ADDENDUM

ADDENDUM NO. [1] Date: October 31, 2019

**RE: WESTERN TECHNICAL COLLEGE
KUMM CENTER COOLING UPGRADES
400 SIX STREET NORTH
LA CROSSE, WISCONSIN 54601
HSR PROJECT NO. 19035**

2 PLATE & FRAME HX PIPING DETAIL
N.T.S.

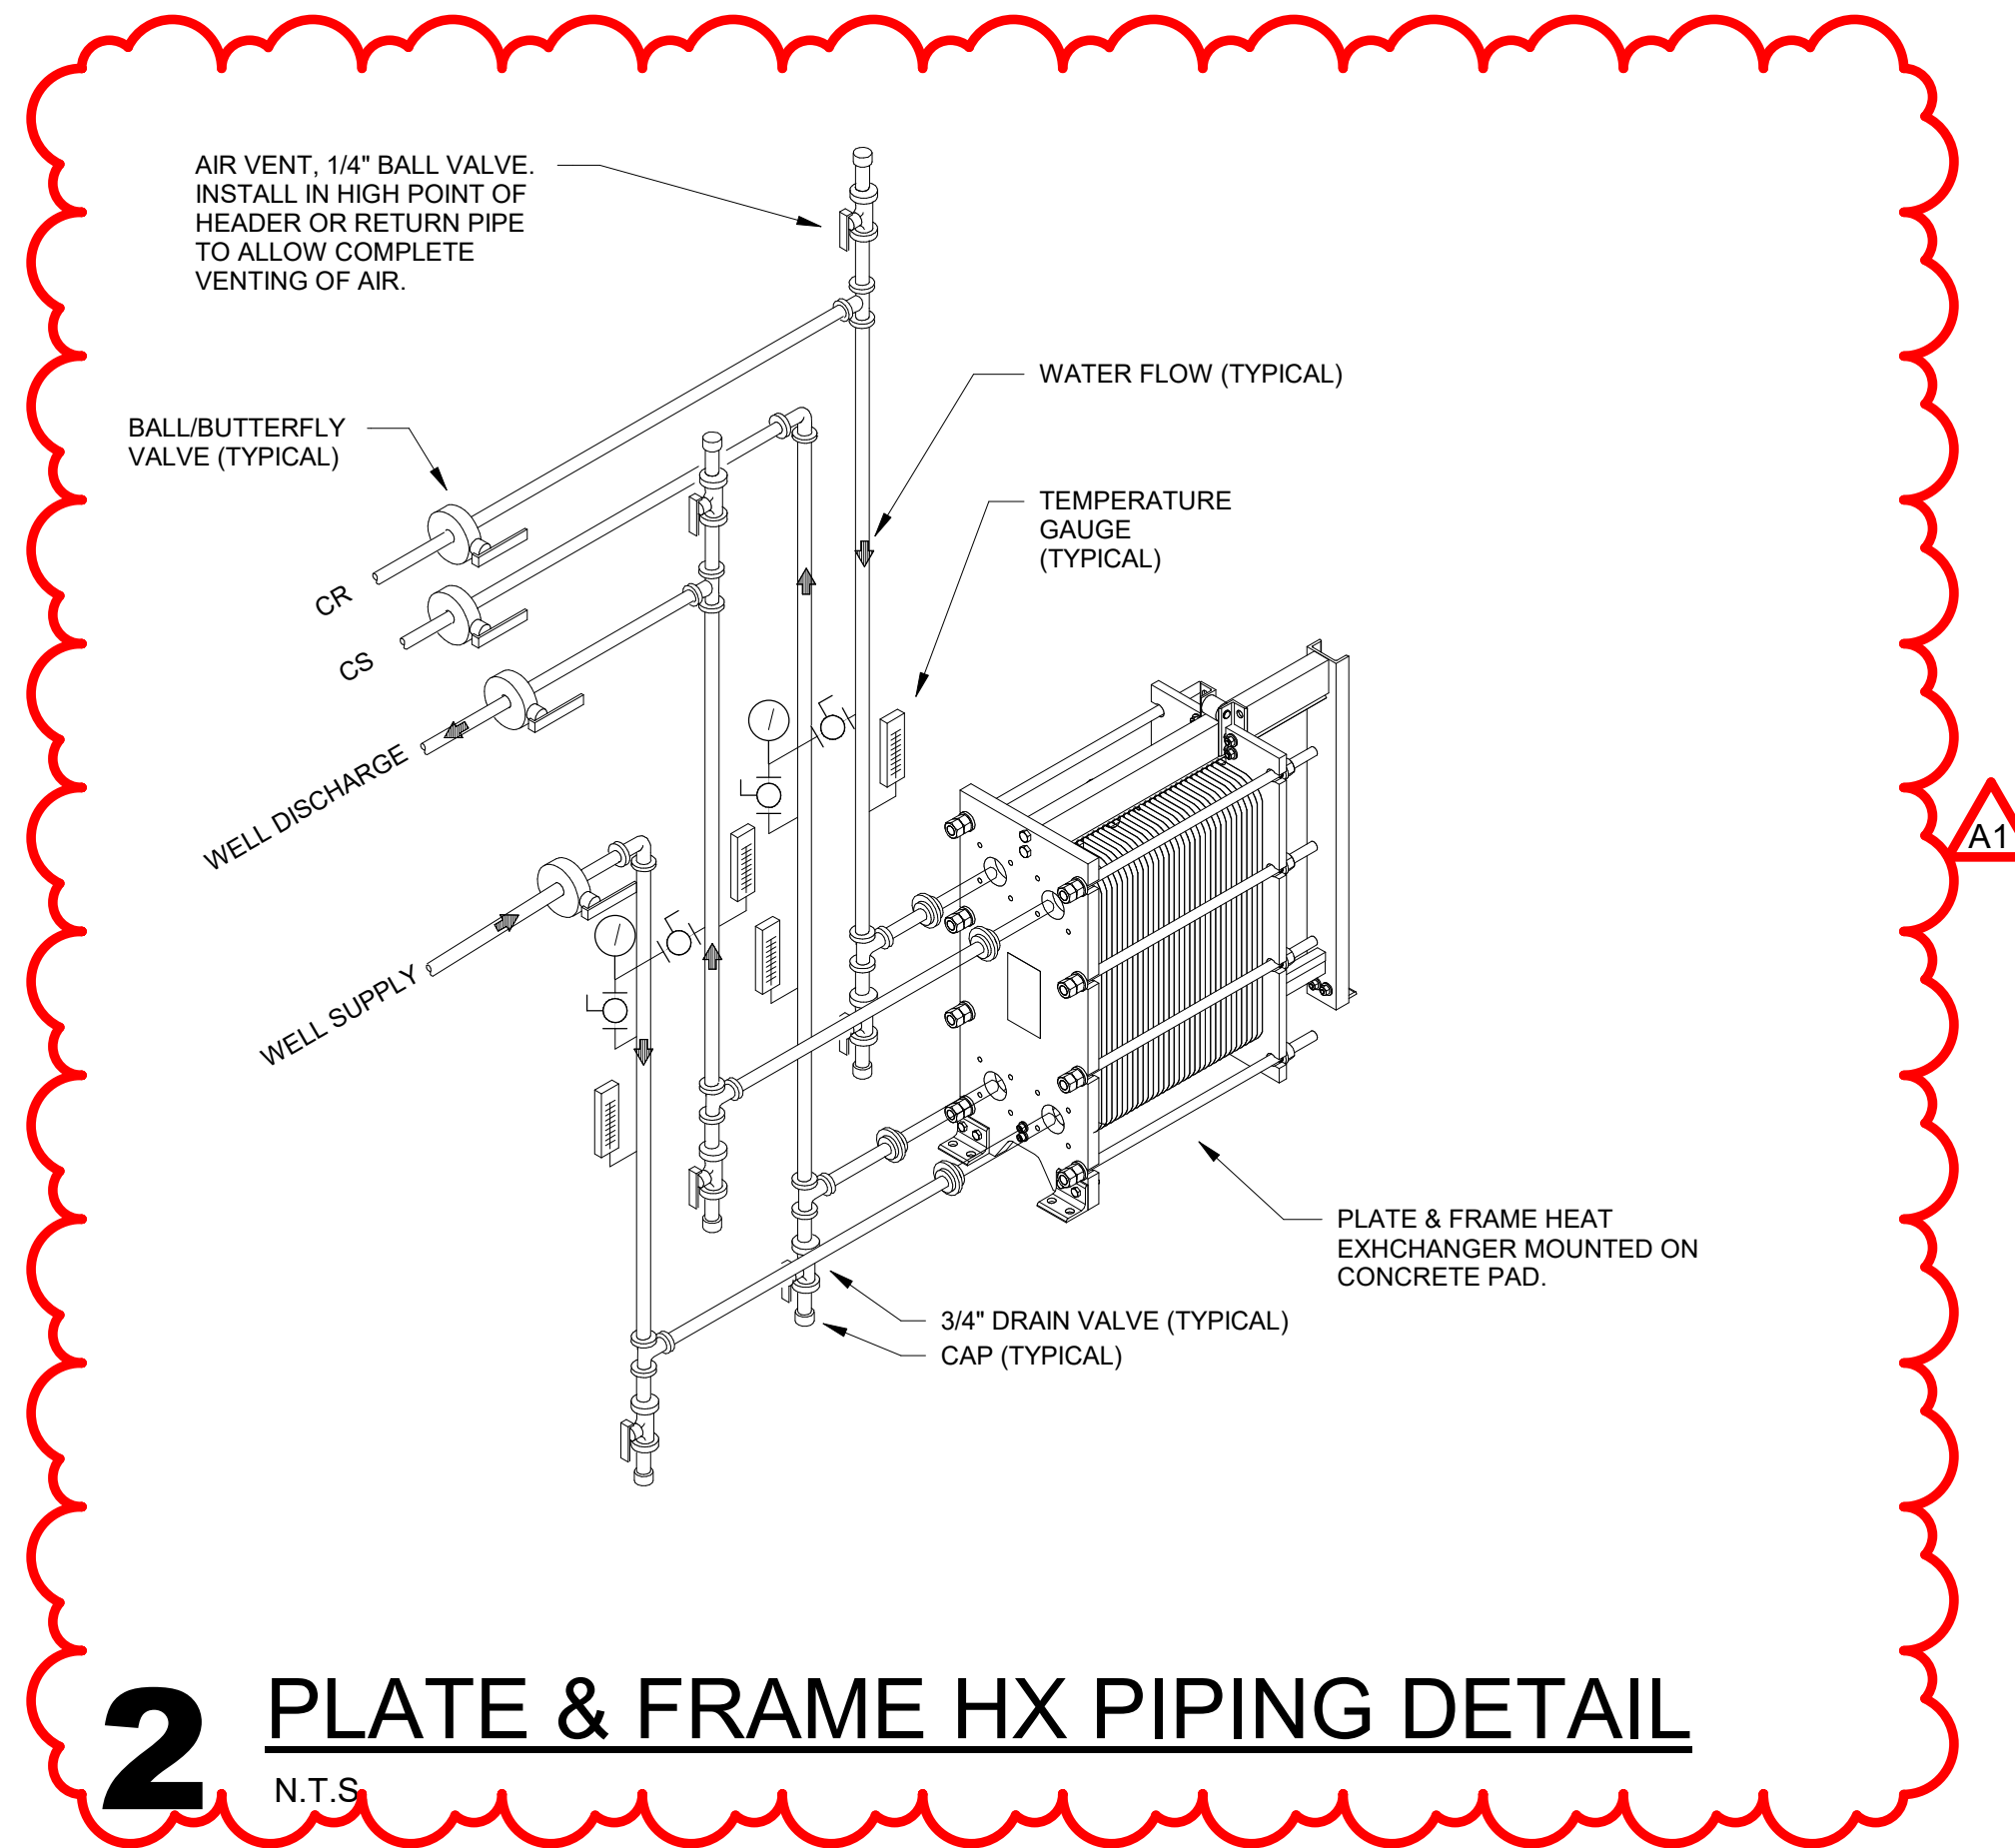
- c. Detail 2M501 PLATE & FRAME HX PIPING DETAIL: Added 3/4" drain valves/caps on each drop to heat exchanger to promote flushing. Revised air vents to be 1/4" ball valves in lieu of manual key type vents.

3 STACKED CHILLED WATER COIL DETAIL 2-WAY
N.T.S.

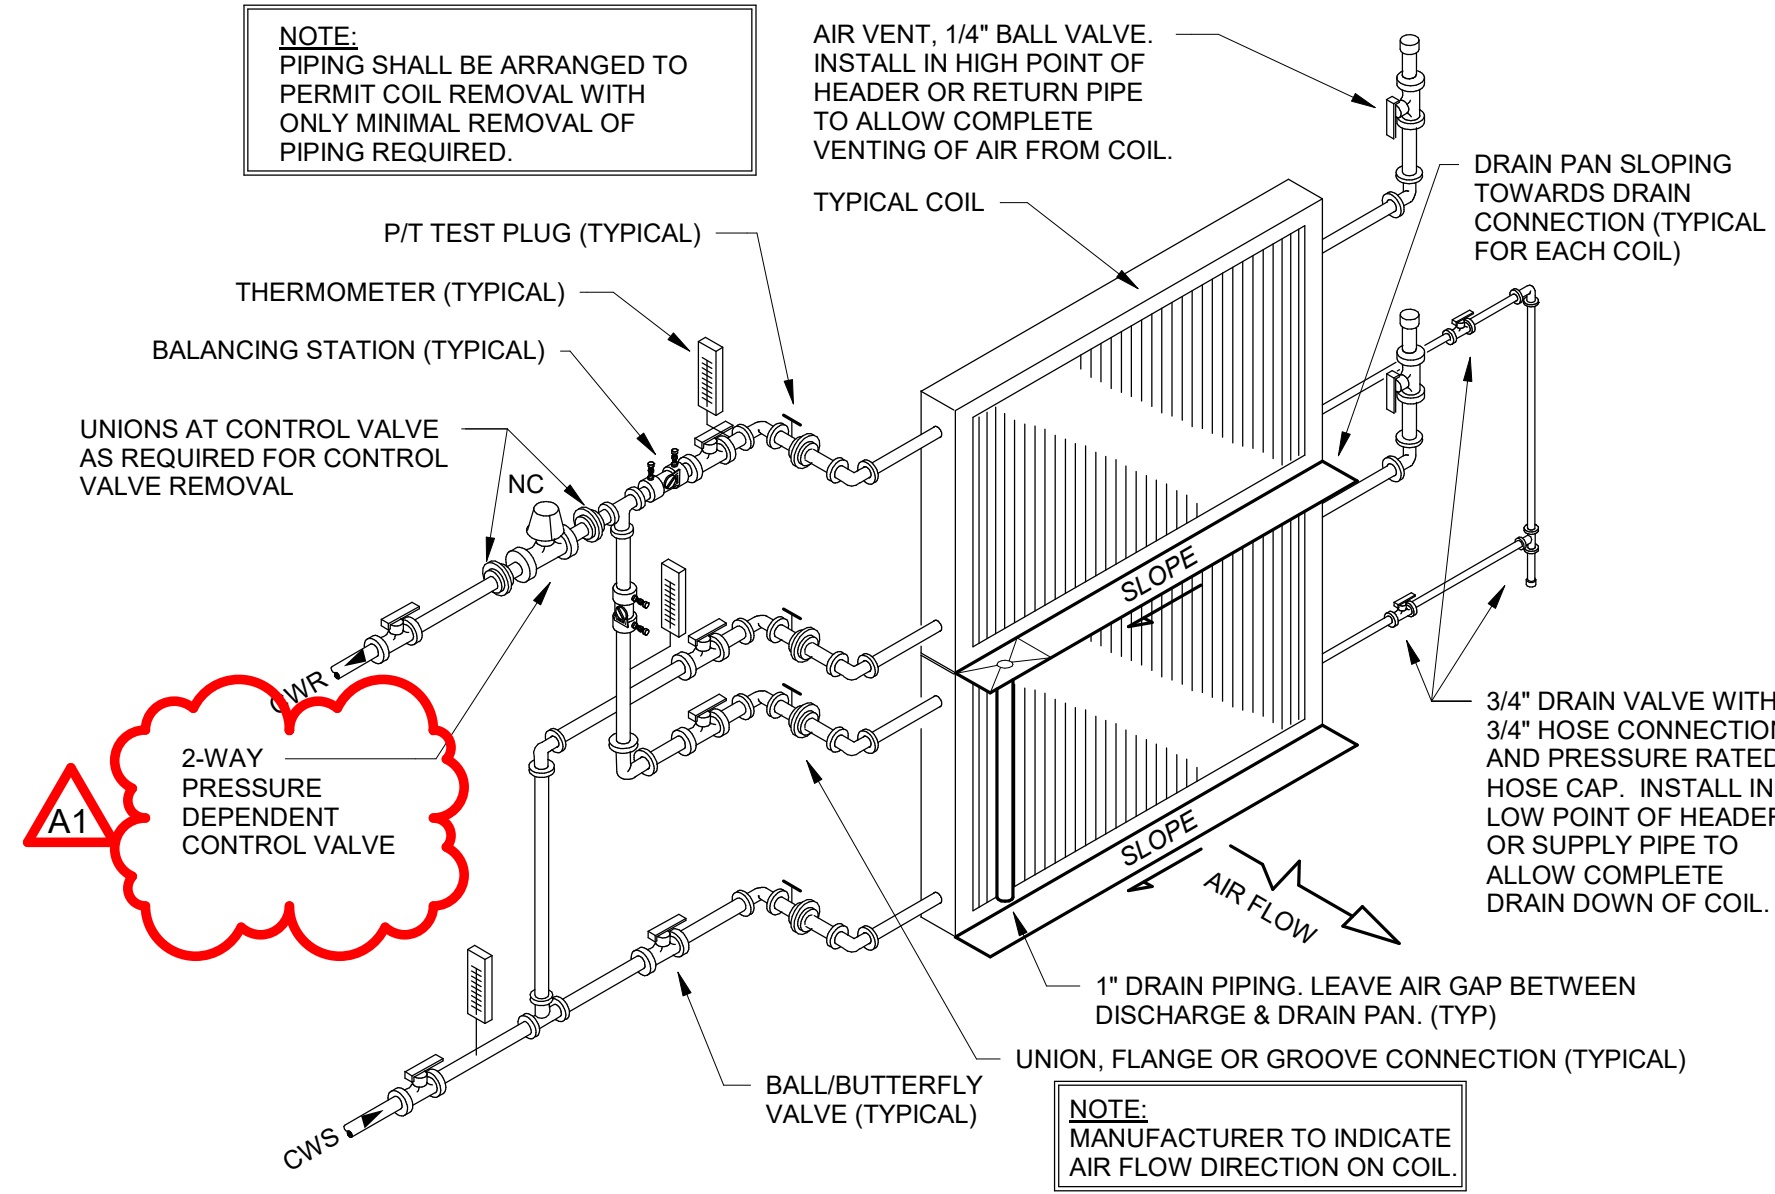
- d. Detail 3M501 STACKED CHILLED WATER COIL DETAIL 2-WAY: Revised 2-way control valve to be pressure depending valve in lieu of pressure independent.

4 INLINE PUMP DETAIL - FLOOR MOUNTED
N.T.S.

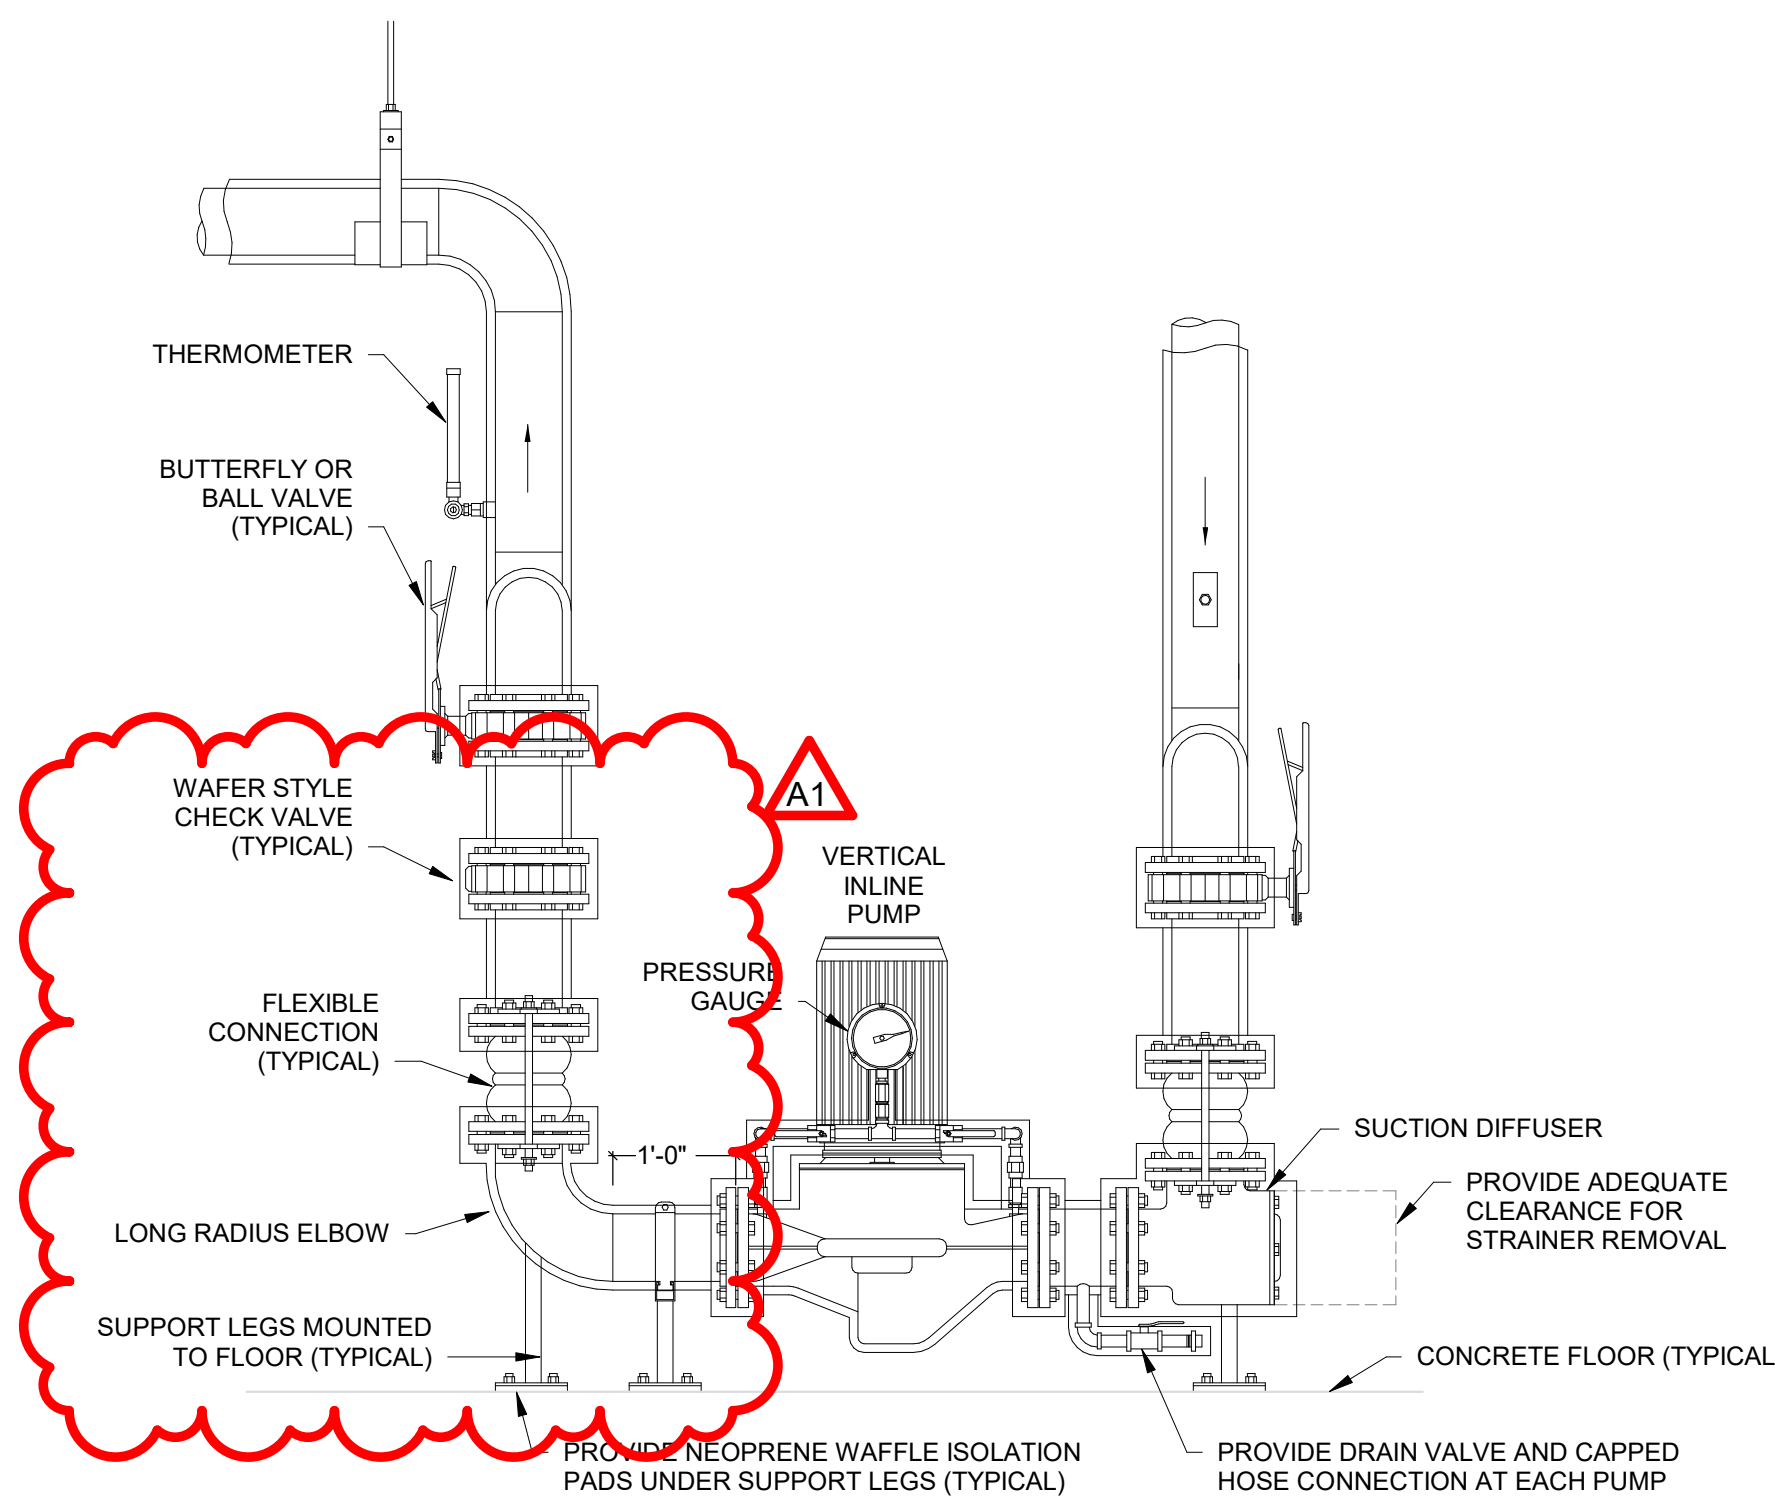
- e. Detail 4M501 INLINE PUMP DETAIL – FLOOR MOUNTED: Removed triple duty valve on discharge of pump and added check valve as noted above under Section 23 21 11.
